AGENDA
COMMITTEE OF THE WHOLE
FEBRUARY 28, 2017
2200 Harnish Drive
Village Board Room
- AGENDA -
7:30 P.M.

SUBJECT: *Case No. 2016-13 Burger King 600 East Algonquin Road—Final PUD and Special Use Permit*

DATE: December 16, 2016
TO: Katie Parkhurst, Senior Planner
FROM: Diane LaCalamita, Building Inspector
SUBJECT: **Proposed signage for Burger King**

3 FRONT ELEVATION
SCALE: 1/4" = 1'-0"

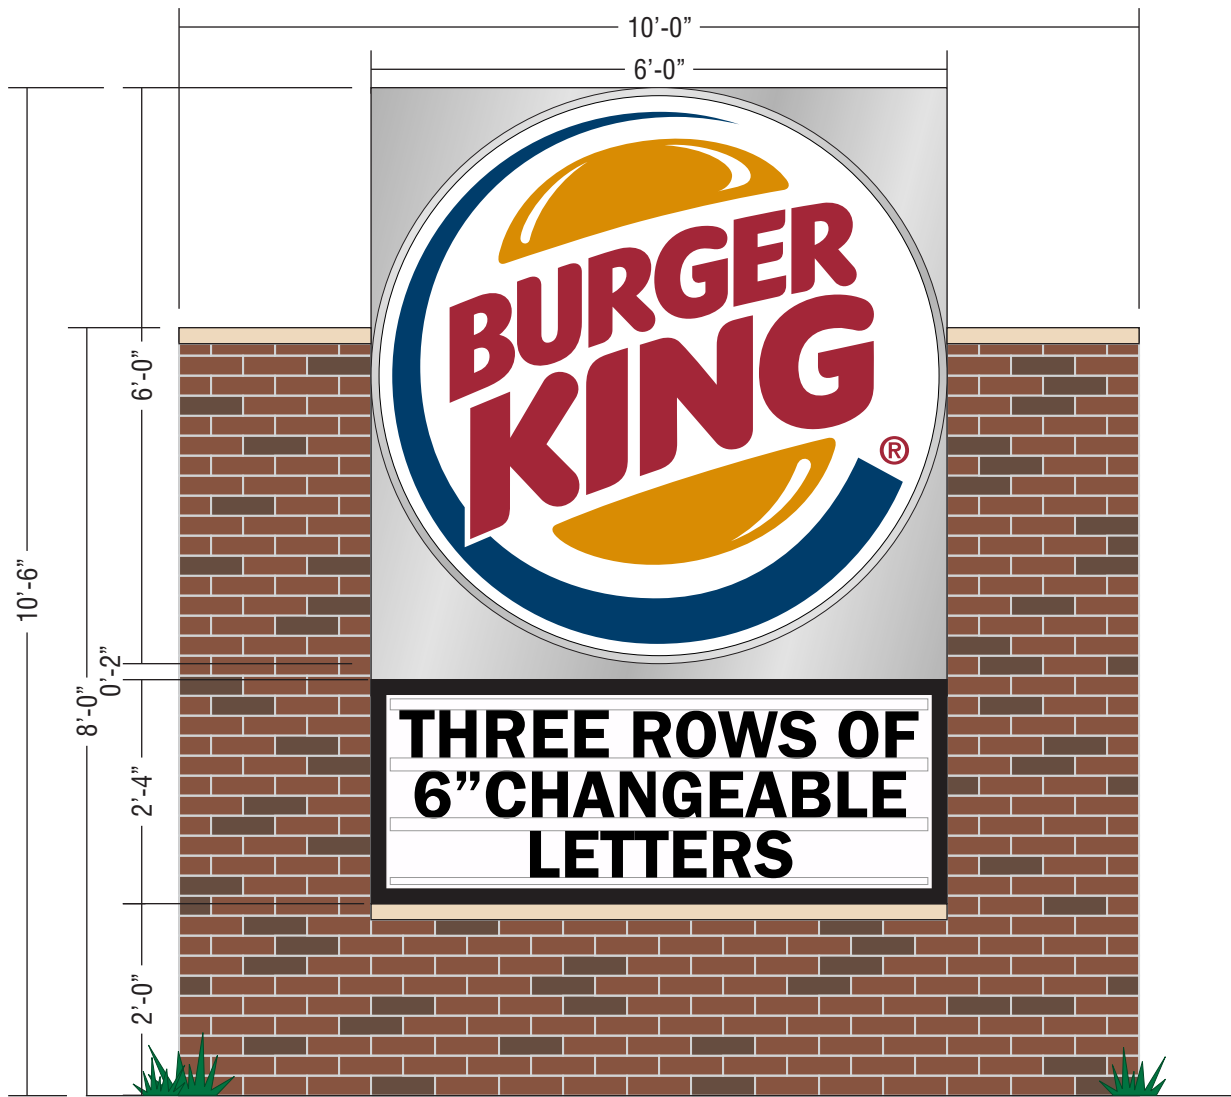
Per your request, I have reviewed the exterior signage proposed for Burger King on E. Algonquin Road. The following are my comments:

1. **Drive-Thru Signage** -- The proposed preview board, ordering station, menu board and clearance bar are all acceptable.
2. **Wall Sign** - The channel letter sign noting "Flame Grilling Since 1954" would not be permitted. We allow for a maximum of two wall signs and such shall be the official name of the business only. They could consider incorporating this verbage on their monument sign.
3. **Wall Signs** - Walls signs are limited to 40" overall height when using two lines of copy. The proposed 6' wall sign is too large.
4. **Monument Sign** - The proposed monument sign is acceptable.
5. **Directional Signs** - The parking lot directional signs are a bit too large as they should not exceed 3 square feet. Only one sign per entrance/exit is permitted per our current Sign Code. There is no height of the sign(s) provided; such should not exceed 3' in height overall.
